SUNDRY NOTICES AND REPORTS ON WELLS

Mescalero Ridge Unit "35" #14

Devon Proposes To Permanitly Plug And Abandon As Follows:

# DEVON ENERGY CORPORATION WELLBORE SCHEMATIC

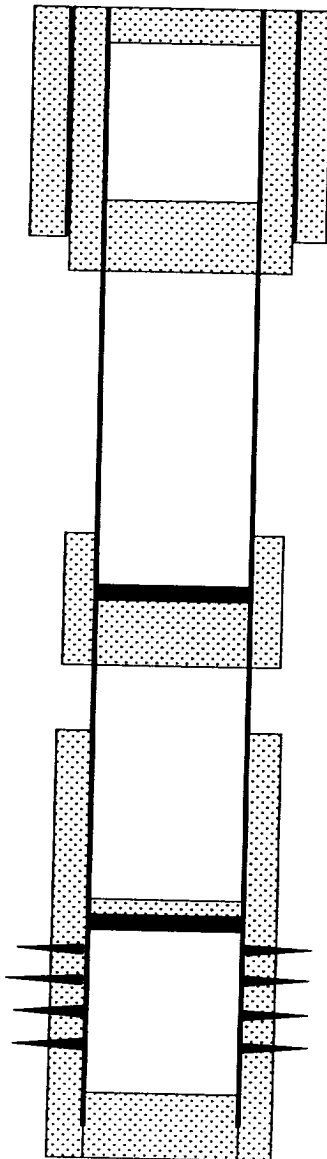
PERF & SQUEEZE (IF POSSIBLE) CEMENT PLUG  
@ 1825' - 1925'
